# Mojave Solar Project (09-AFC-5C)

Petition to Amend

COMPLIANCE 14-05-00

Figure 1. MSP Alpha (North) and Beta (South).

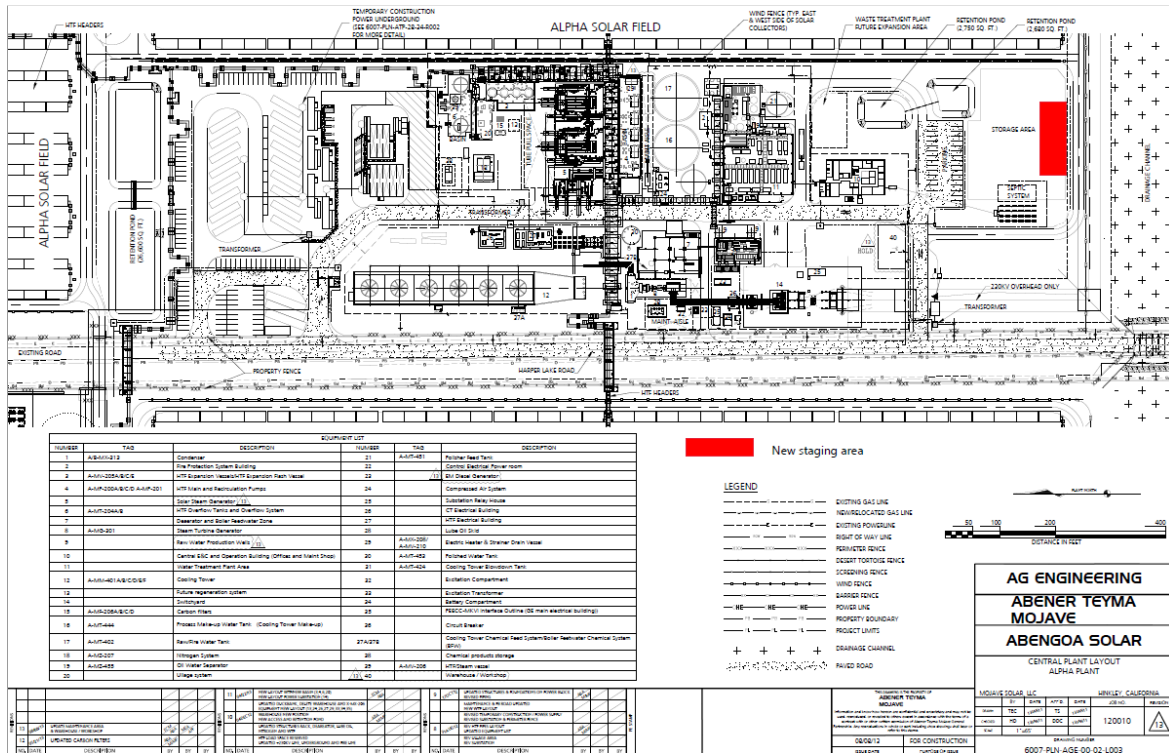
This Petition does not affect any Project parcel, nor any existing installation within the facility. The new staging area will be located at the South Easternmost lot of the Alpha Power Block Plant, see figure 1 and 2 for area location.

SITE PLAN

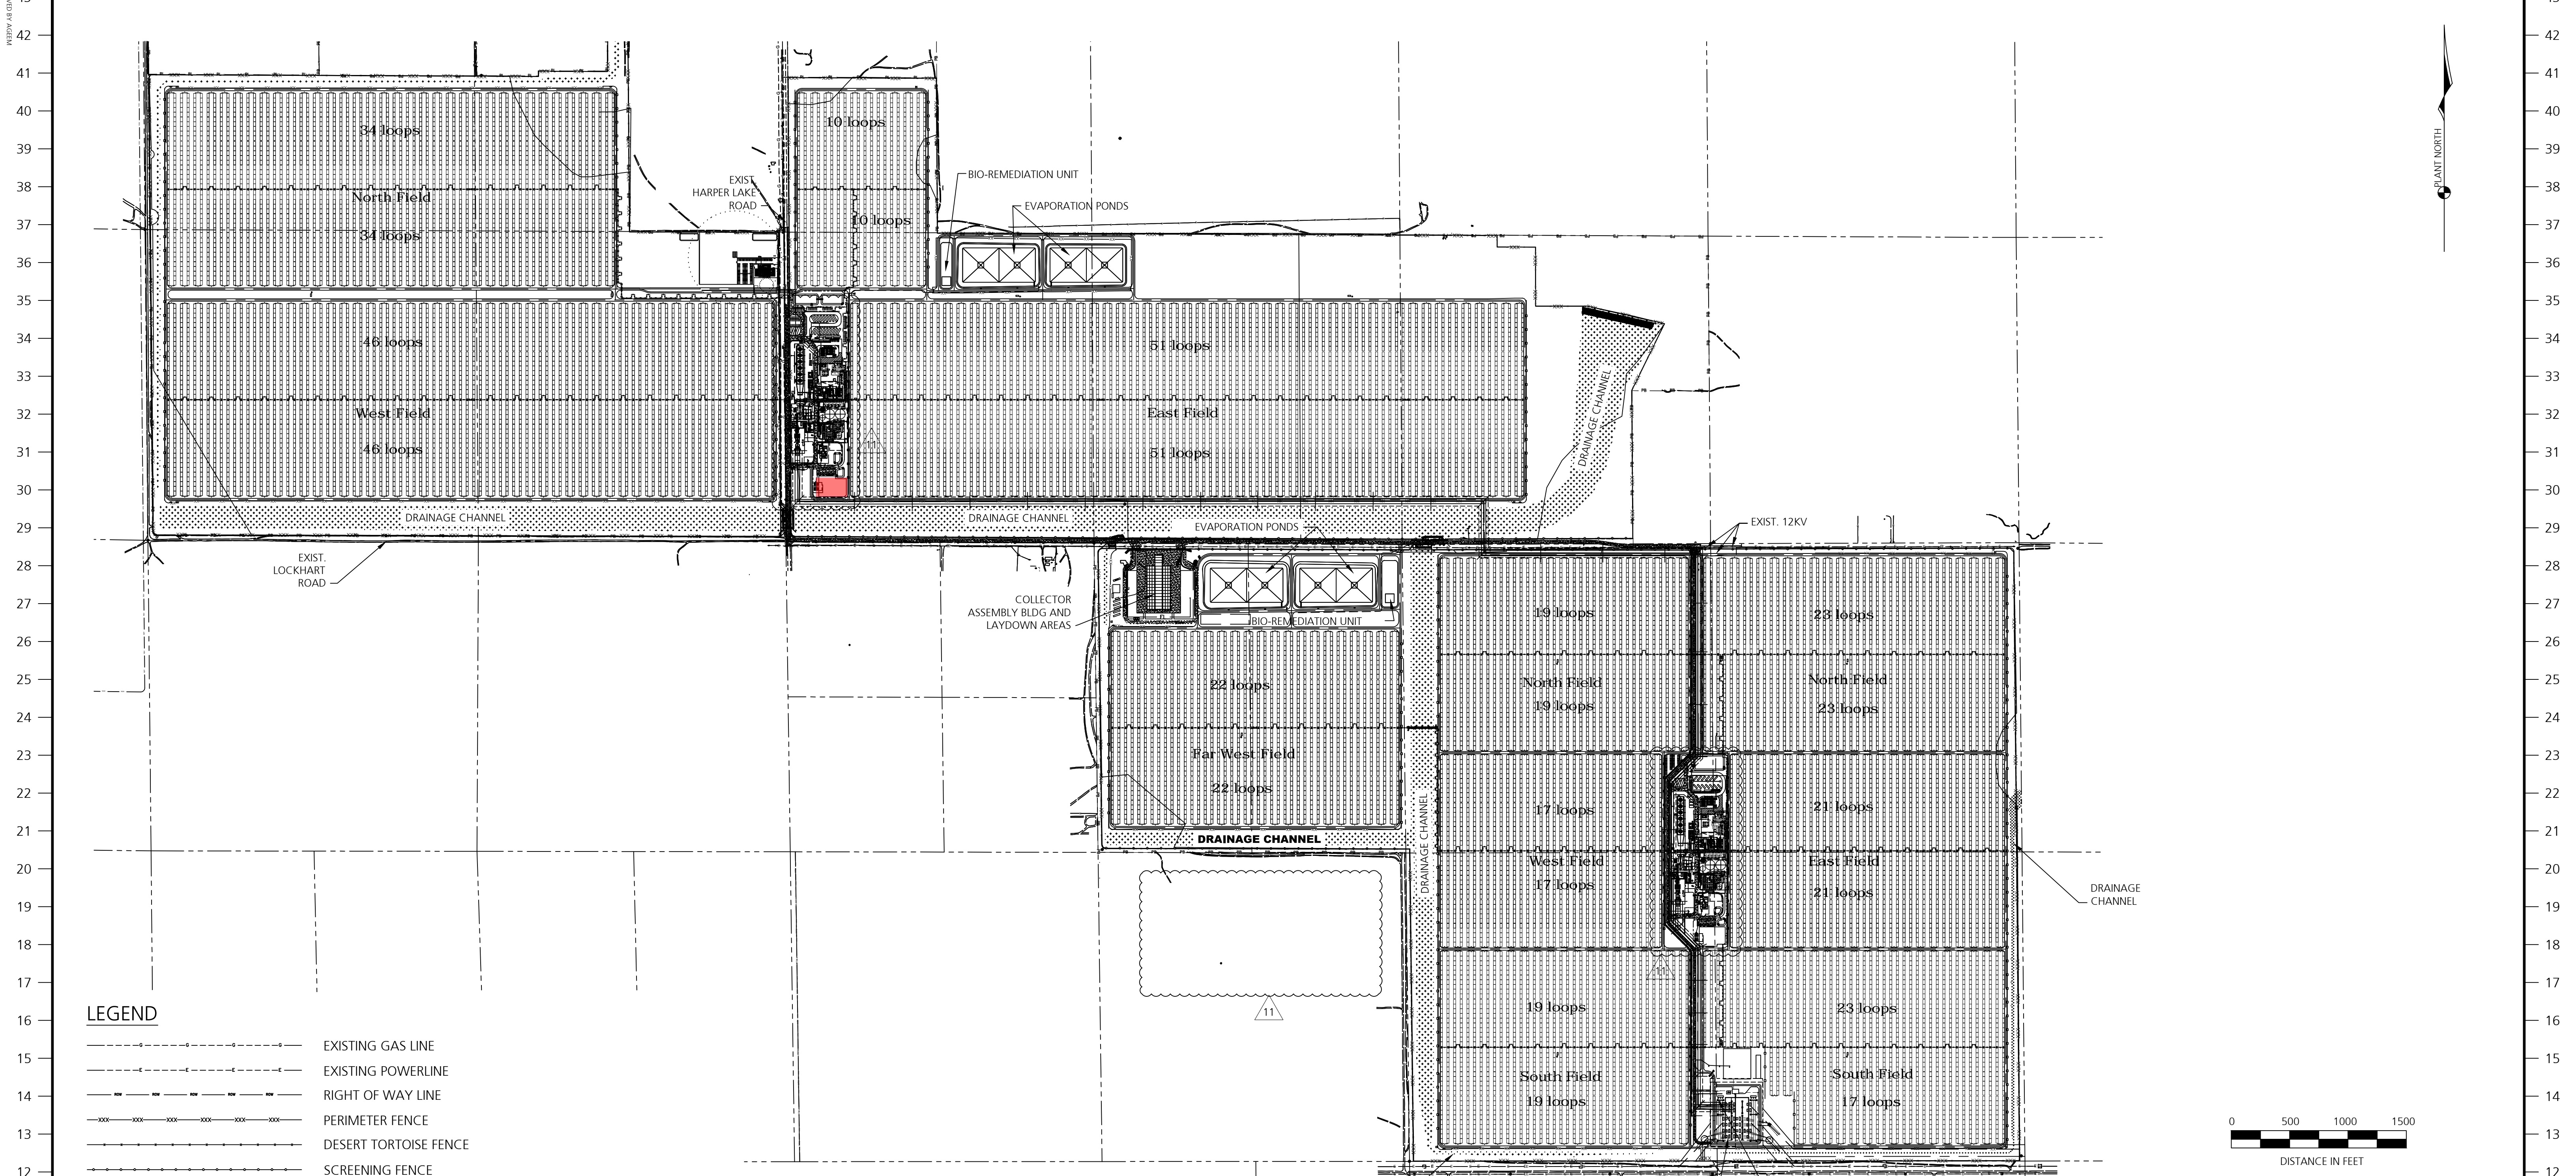
New staging area

CENTRAL PLANT LAYOUT  
 ALPHA PLANT

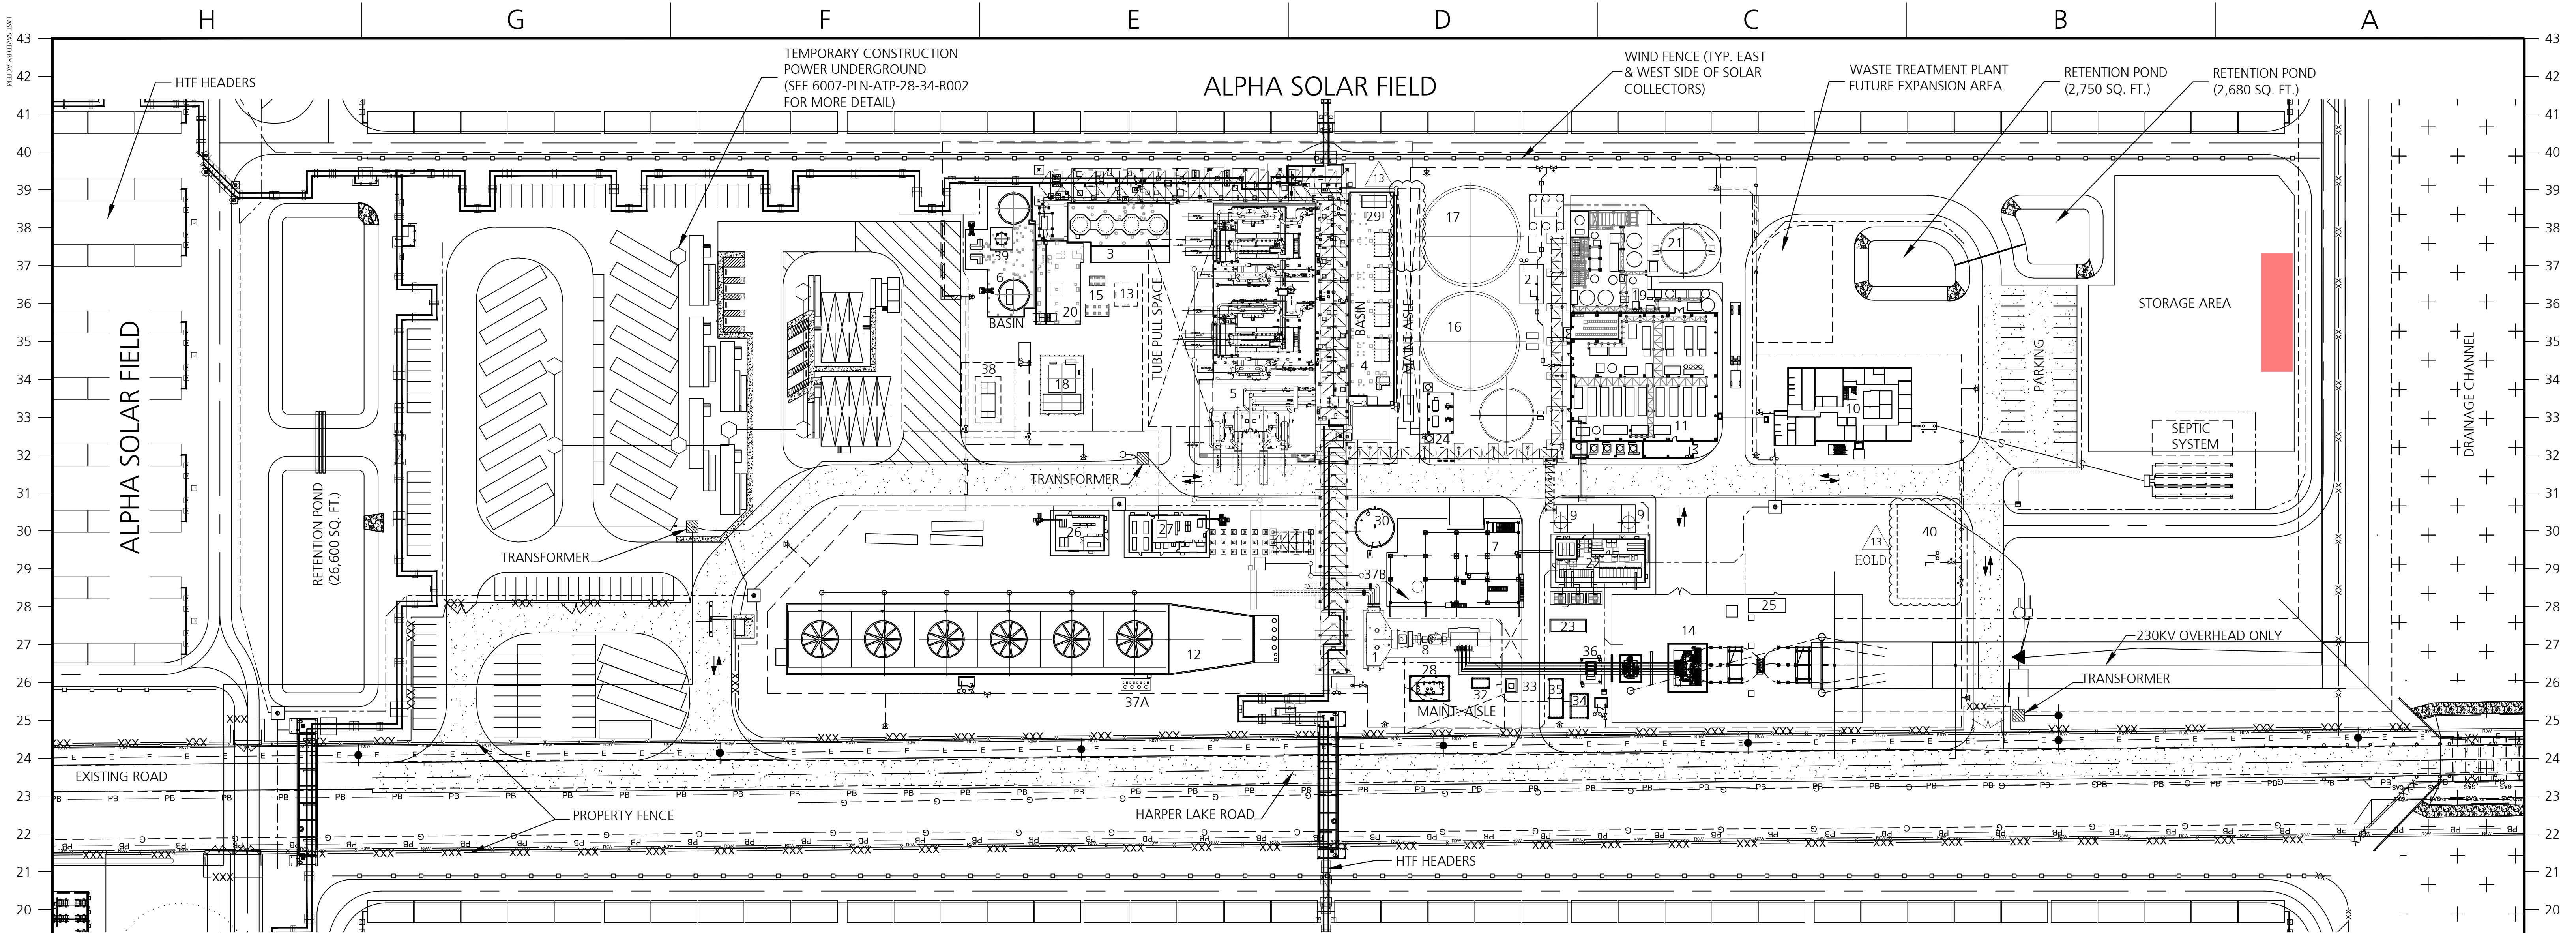
New staging area

Floor plan

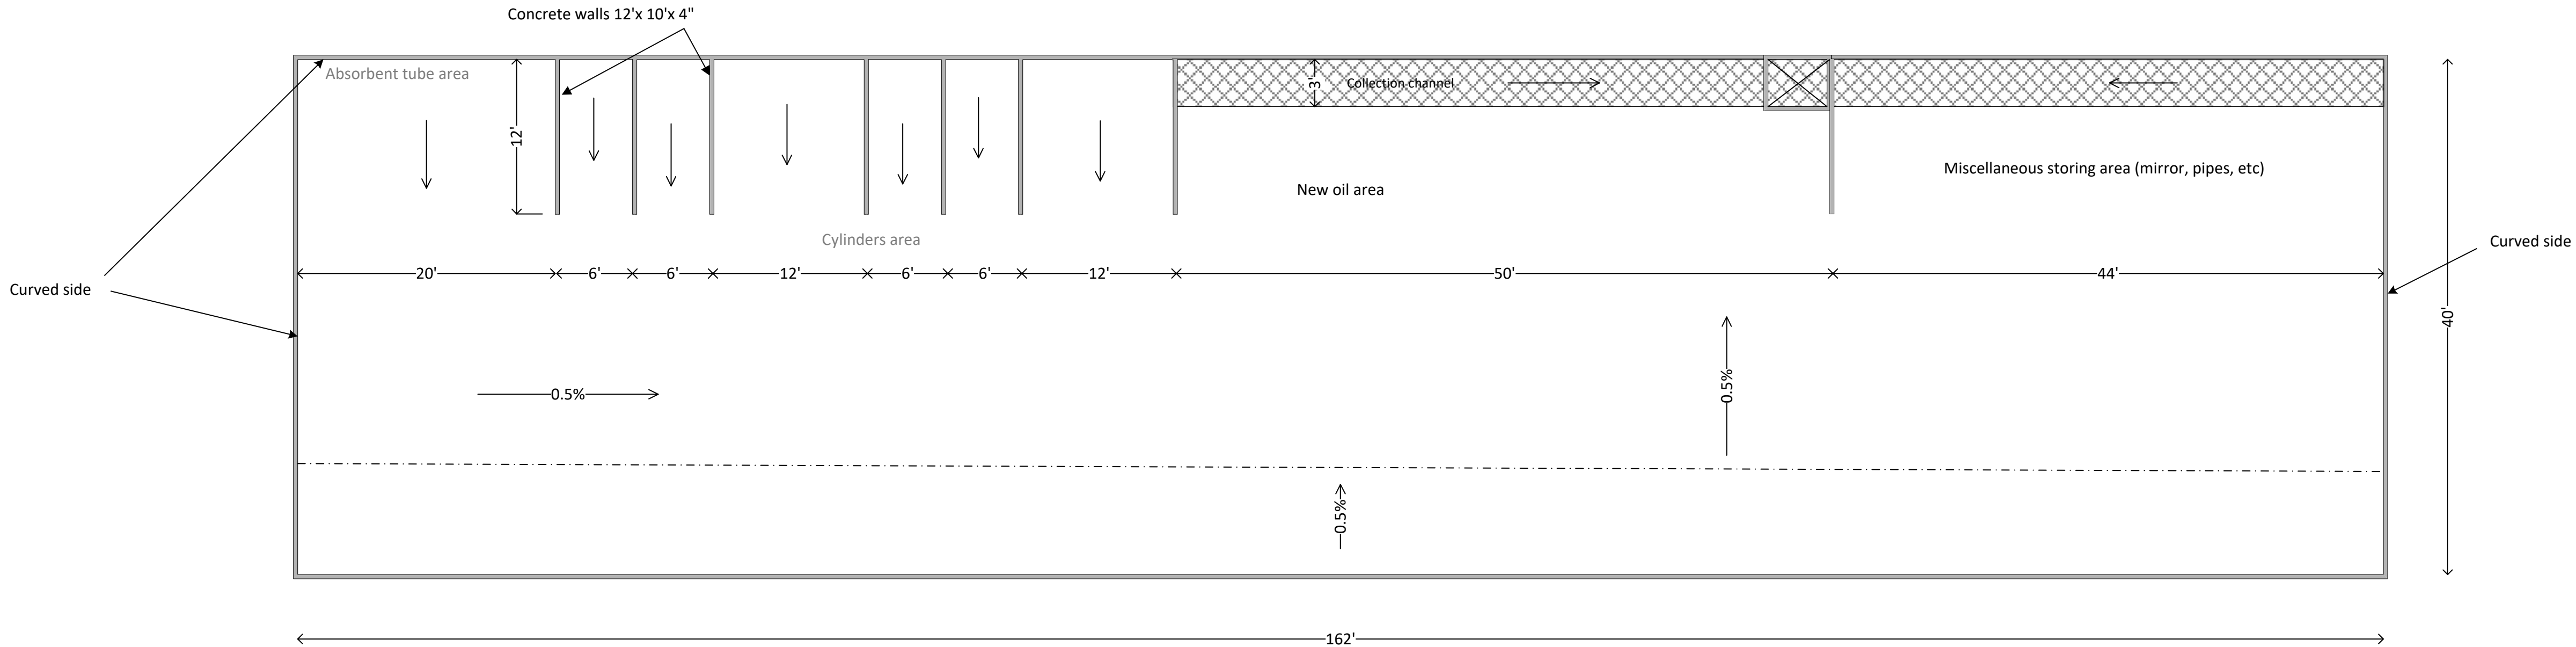
ASIO MSP New staging area

Roof plan

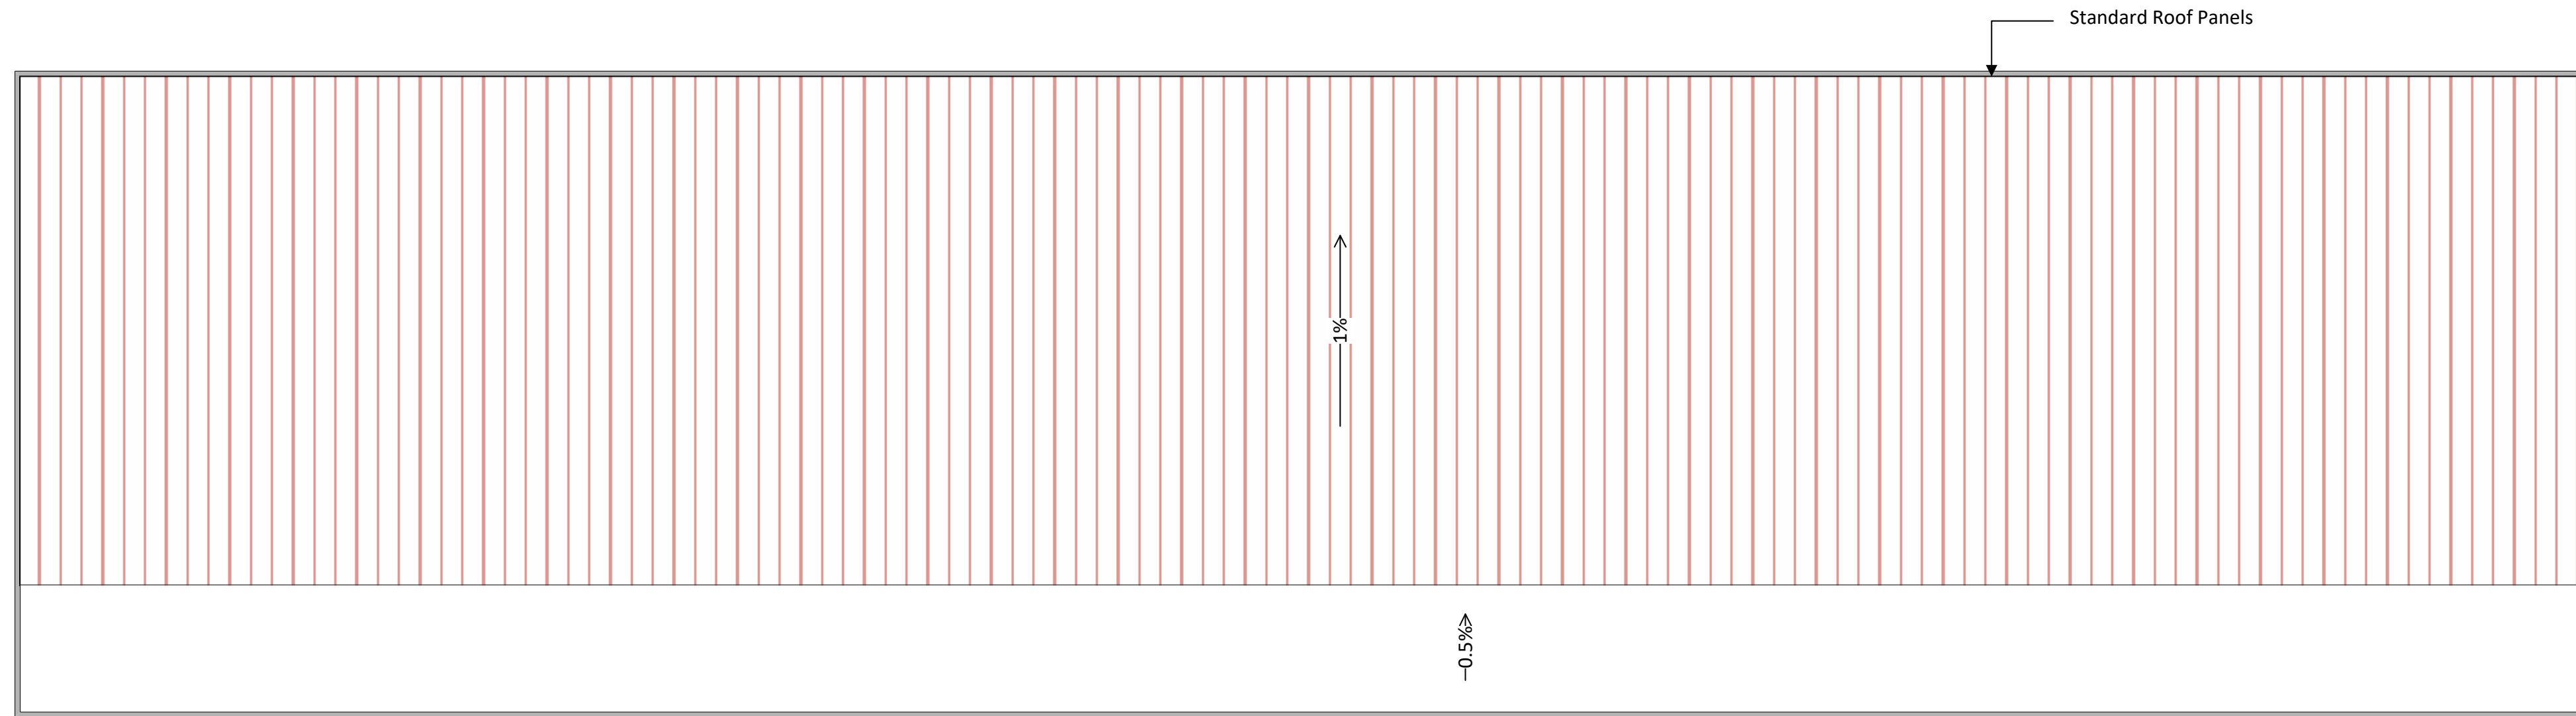
ASIO MSP New staging area
